Re: FortisBC Inc. (FBC)

2016 Long Term Electric Resource Plan (LTERP) and Long Term Demand Side Management Plan (LT DSM Plan)

Response to the British Columbia Utilities Commission (BCUC or the Commission) Information Request (IR) No. 2

1 **Figure 1: Net Load Forecast LTERP vs. Adjusted with Before-Savings Annual UPC**
 2 **Decreased by 0.5 Percent**

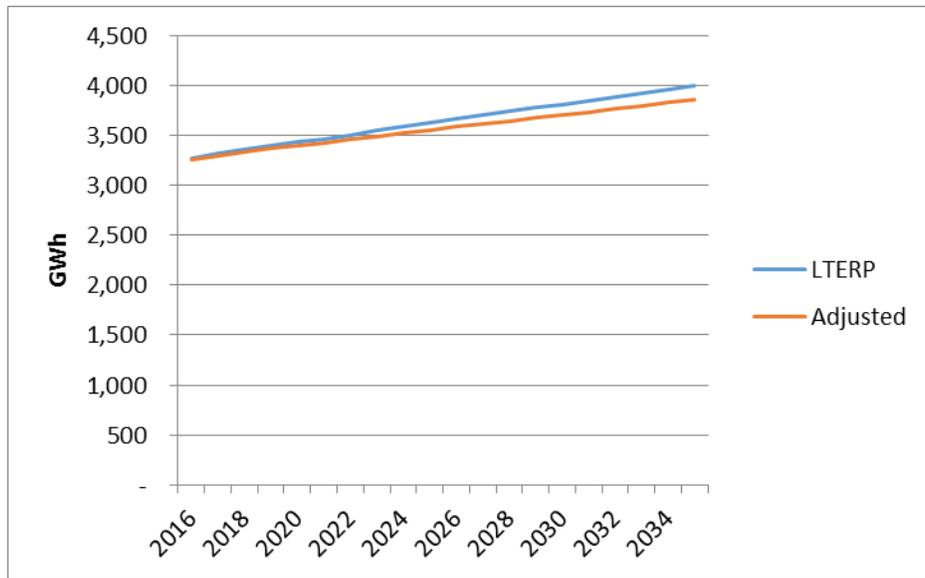
56.5 Please calculate the impact to the (i) residential forecast, (ii) total gross load forecast, and (iii) total net load forecast (presented in Appendix F of the Application) of using a forecast normalized before-savings pre-DSM residential UPC that declines at 0.5% per year for each year of the 20-year planning period. Please provide the necessary tables and charts with your response.

3
 4 As shown in the table and figure above, a compounding 0.5 percent decrease in the residential
 5 UPC results in a residential load estimate that is more than 9 percent lower by 2035 than the
 6 forecast as filed. In terms of overall net load, the impact is 3.7 percent.

1 **Figure 1: Net Load Forecast LTERP vs. Adjusted with Before-Savings Annual UPC**
 2 **Increased by 0.5 Percent**

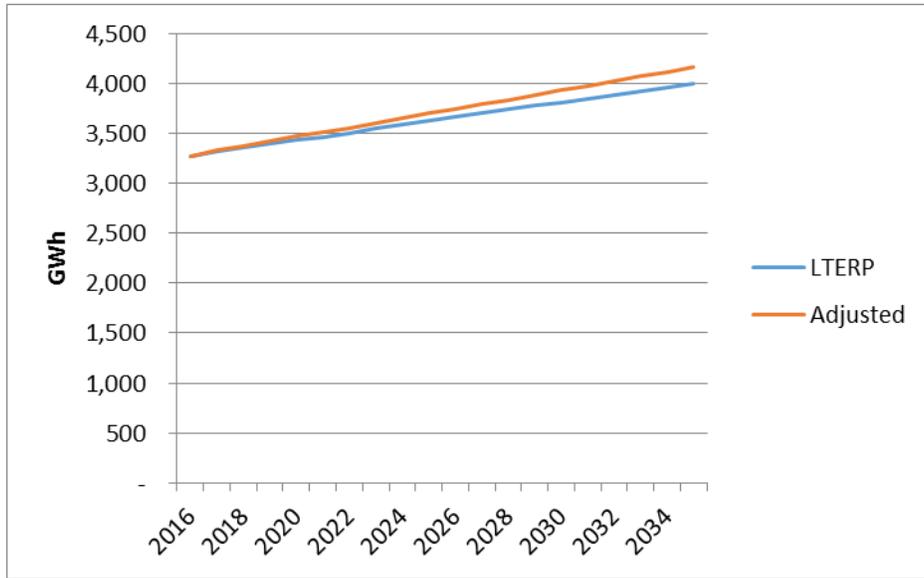
9
 10 56.6 Please calculate the impact to the (i) residential forecast, (ii) total gross load
 11 forecast, and (iii) total net load forecast (presented in Appendix F of the
 12 Application) of using a forecast normalized before-savings pre-DSM residential
 13 UPC that increases at 0.5% per year for each year of the 20-year planning
 14 period. Please provide the necessary tables and charts with your response.

3
 4 As shown in the table and figure above, a compounding 0.5 percent increase in the residential
 5 UPC results in a residential load estimate that is more than 10 percent higher by 2035 than the
 6 forecast as filed. In terms of overall net load, the impact is 4 percent.

Figure 1: Net LTERP Load Compared to Net Load with City of Penticton Load Decreased by Six Percent

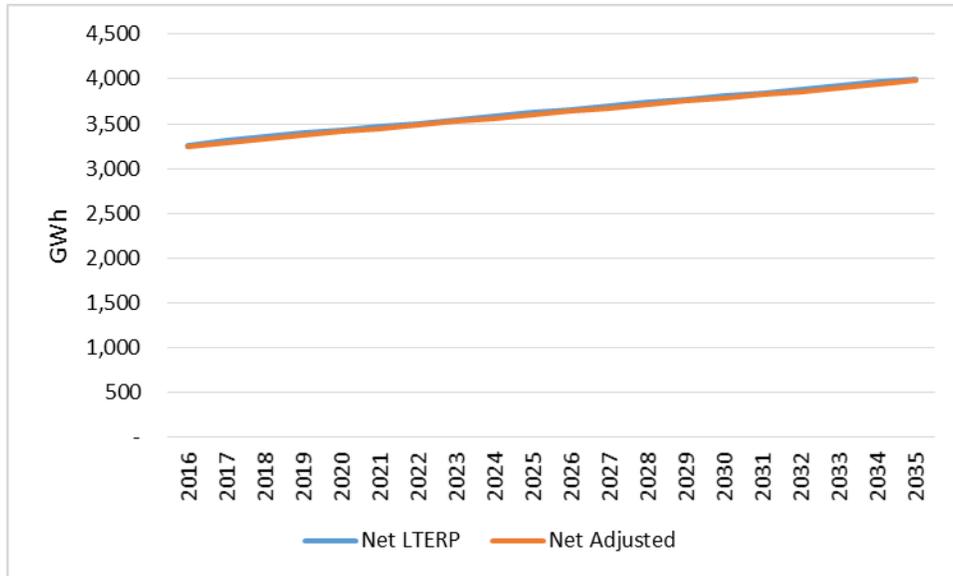
14 57.1 Please calculate the impact to the (i) wholesale load forecast, (ii) total gross load
15 forecast, and (iii) total net load forecast (presented in Appendix F of the
16 Application) if the Penticton load forecast for each year in the planning period
17 was 6 percent less than forecast in the Application. Please provide the necessary
18 tables and charts with your response.

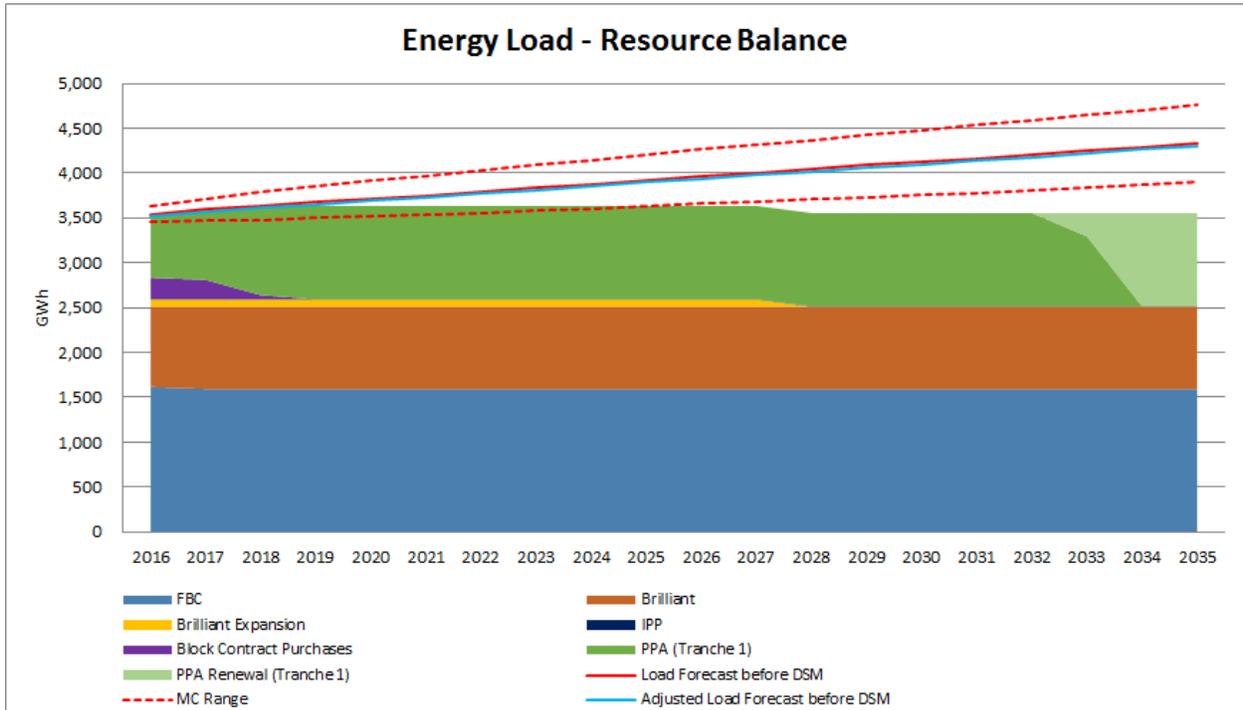
57.1.1 Please discuss, and provide updates where necessary, whether this would impact the FBC's load-resource balance as seen in figure 7-1 in the Application.

The impacts discussed in the response to BCUC IR 2.57.1 would not have a material impact on FBC's LRB as seen in Figure 7-1 of the LTERP. An updated version of this figure is provided below showing the adjusted load forecast in light blue.

- 1
- 2 The impact is immaterial because the impact of the 6 percent lower load forecast for Penticton
- 3 results in a less than 1 percent impact on the overall net load forecast.
- 4

Figure 1

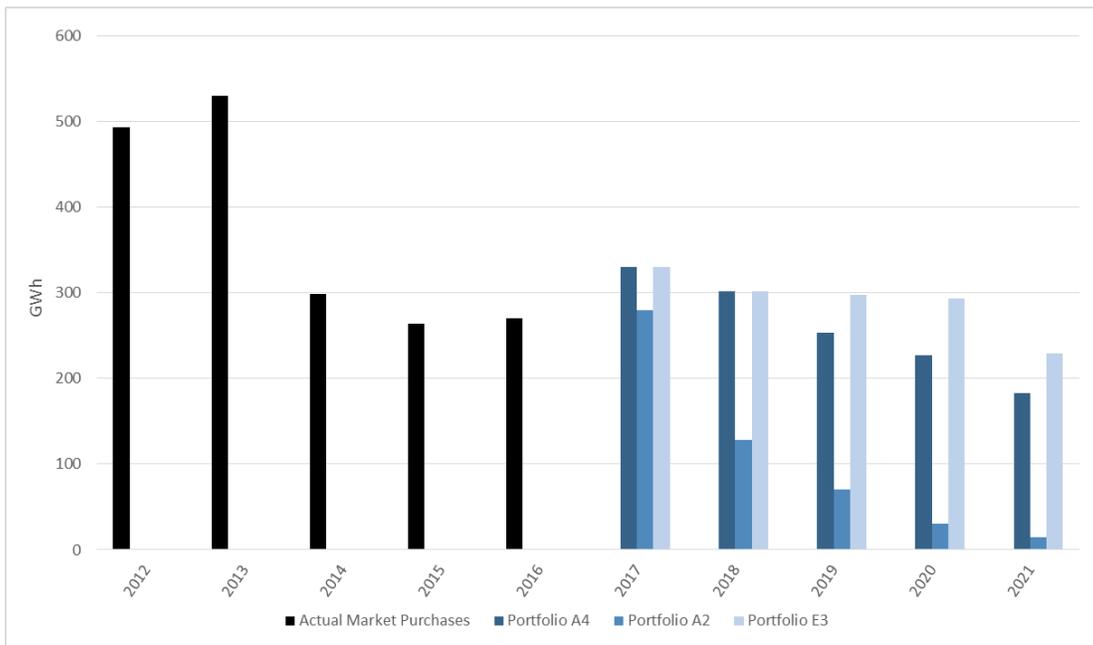
63.1.1 In table and graphical form, please show FBC market purchases for the previous five years (2012-2016), those proposed for 2017-2021 in portfolio A4, and those proposed for any significantly different alternative portfolio(s) identified above (i.e., same market price assumption but significantly different market energy purchase volumes). Please explain any change in historical/forecast market purchases over time.

8 Also included in Figure 1 and Table 1 are the forecast market purchase volumes¹⁰ under FBC's
 9 preferred Portfolio A4 as well as market purchases within Portfolio A2 and Portfolio E3.
 10 Portfolio A2 has lower market purchase volumes relative to other portfolios, whereas portfolio
 11 E3 has higher market purchase volumes relative to other portfolios. Portfolio A2 assumes a
 12 high Mid-C pricing scenario, which accounts for the lower volume of forecast market purchases.
 13 Portfolio E3 assumes a high PPA purchase price scenario with the base Mid-C pricing scenario,
 14 which accounts for the higher forecast volume of market purchases as market purchases
 15 become more economical relative to PPA. Portfolio A4 assumes the reference case load
 16 forecast, base case Mid-C prices, and base case PPA prices.

17 Although the forecast market purchases shown in the Figure 1 and Table 1 are for the next five
 18 years, the market purchase volumes from the LTERP are not intended to be prescriptive. FBC's
 19 short term market purchase strategy is outlined in the AECF and varies with real-time
 20 conditions. Please refer to the response to BCUC IRs 2.63.2 and 2.64.2 for further discussion.

Figure 1

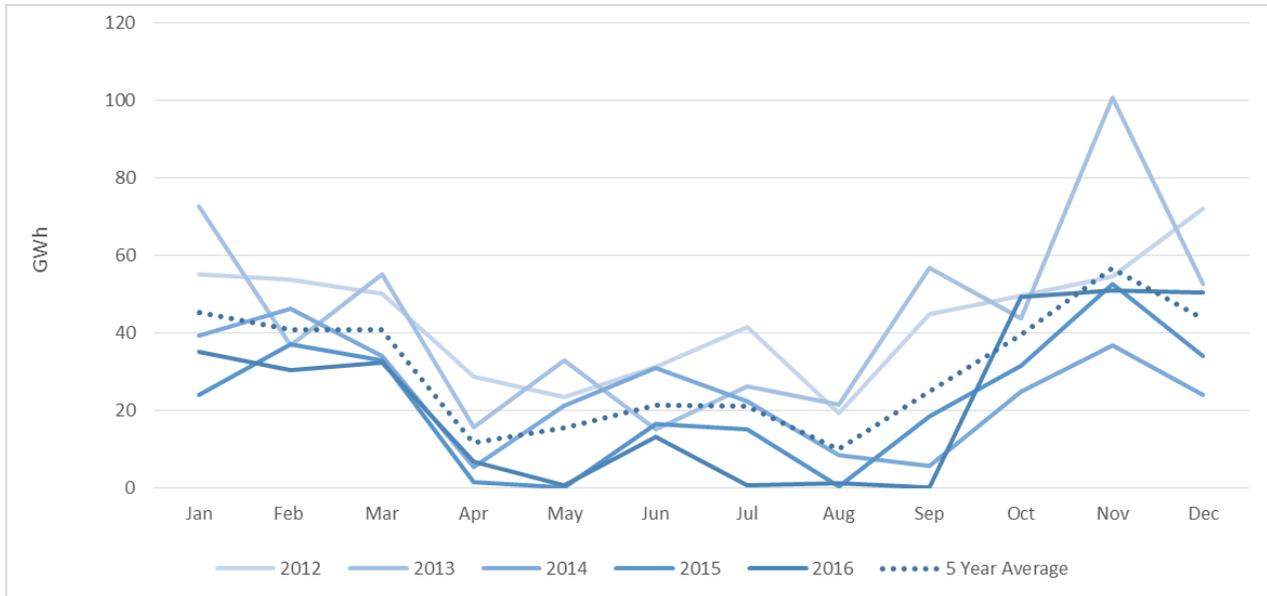
9 FBC states in BCUC IR 18.2 “The market price forecast presented in Figure 2-9 of the
 10 LTERP does not include the risk of market price spikes since it presents average prices
 11 on an annual basis.” FBC provides the average unit cost for FBC’s market energy
 12 purchases from 2012 to 2016 in Shadrack 10 (ii):

19 Please refer to Table 1 and Figure 1 below, which show FBC’s market purchase volumes by
 20 month delivered during each year from 2012 to 2016 as well as a five year monthly average.

Figure 2

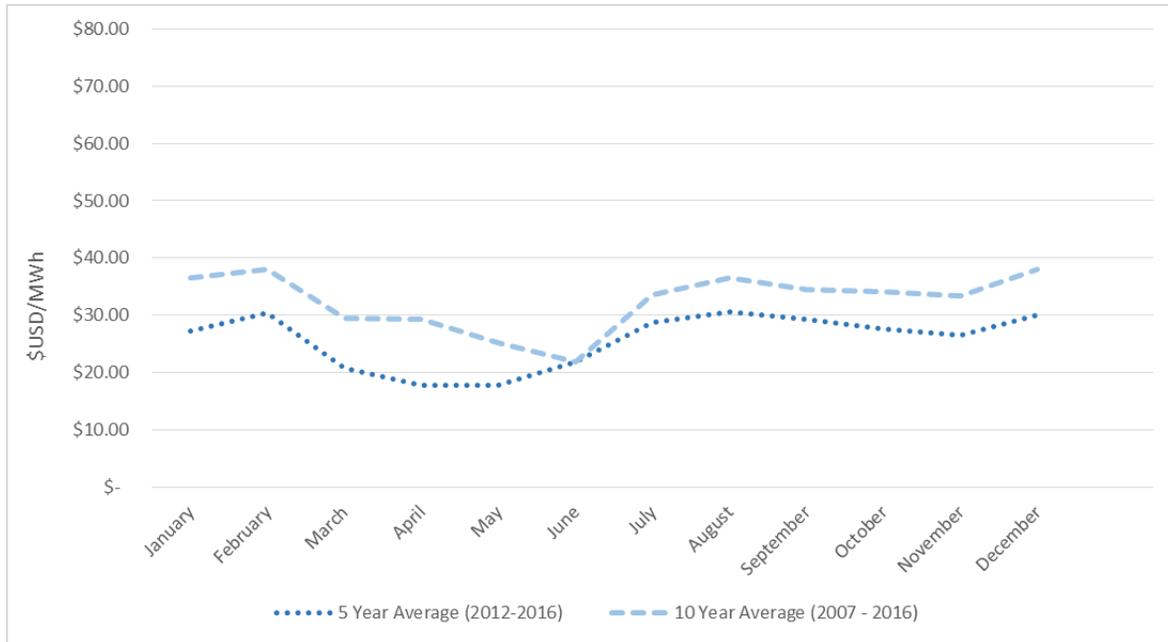
32
33 67.3 Please shows the results to CEC IR 19.3 graphically, showing the results for
34 each year from 2012-2016 with a five year average. In a separate graph, please
35 compare the five year average (2012-2016) with a ten year average (2007-2016).
36

6 Figure 2 below shows the 2012-2016 five year average historical Mid-C day ahead prices on a
 7 monthly basis as well as the 2007-2016 ten year average.
